**E4445A-15**

**S E R V I C E N O T E**

PSA Series Spectrum Analyzers with Options 233 and 110,  
and Option Driver Assembly p/n E4440-60253

**Tuned RF Level Range 2 to Range 3 Switching Time Improvement**

**Figure 1. Option Driver assembly location. E4448A shown**

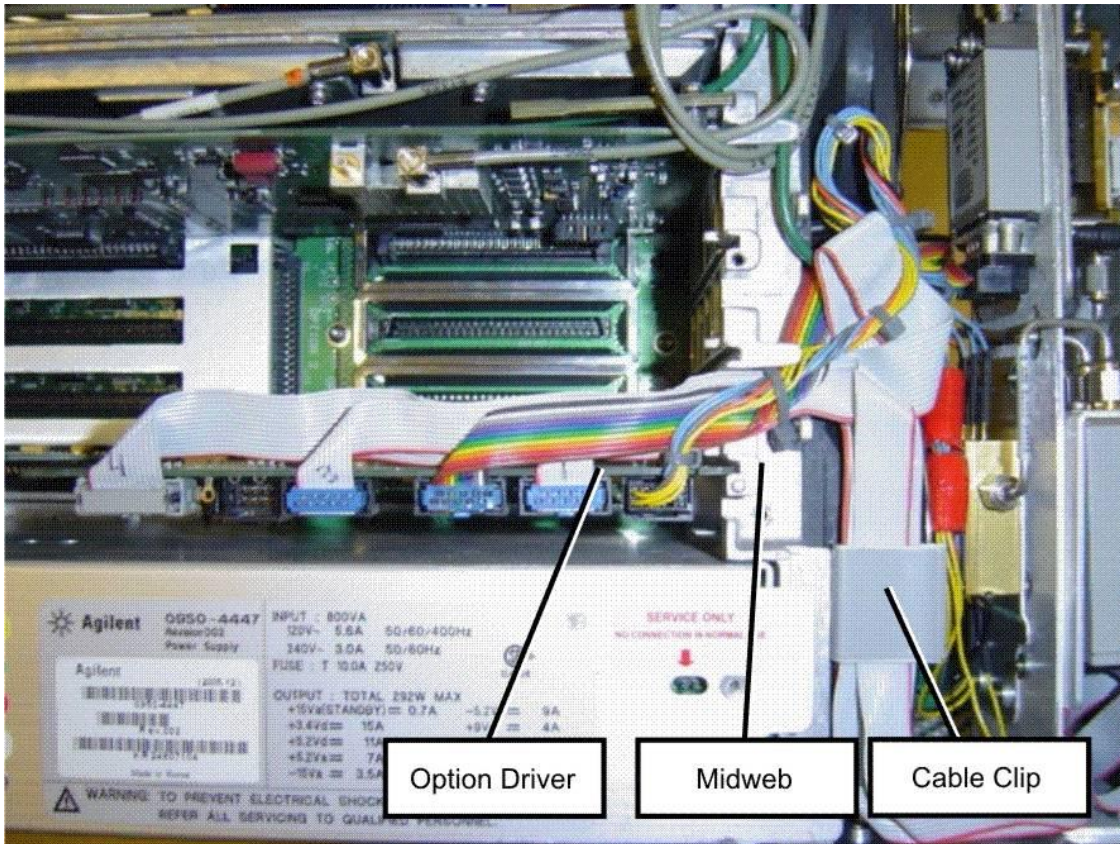
1. Remove the analyzer’s outer case and top brace. See the PSA Service Guide for the procedure to remove and replace these covers.
2. With the instrument powered down, locate the Option Driver assembly shown in **Figure 1**. Notice how the ribbon cables connected to the board assembly are routed near the instrument fans. This

routing prevents damage to the cables when the top brace is installed.

3. Without removing any cables from the option driver, carefully unseat the board assembly from the motherboard. You will need to remove the ribbon cables from the cable clip and possibly remove the cable tie near the mid web. Pull the board out of the instrument only far enough to expose connector J2.
4. See Figure 2. Locate J2 near the middle of the board. Connect the ribbon cable from the Parallel Cable's pod to the JTAG connector, J2, on the A38 option Driver Assembly being careful to align the keying tab on the cable with the J2 header slot.
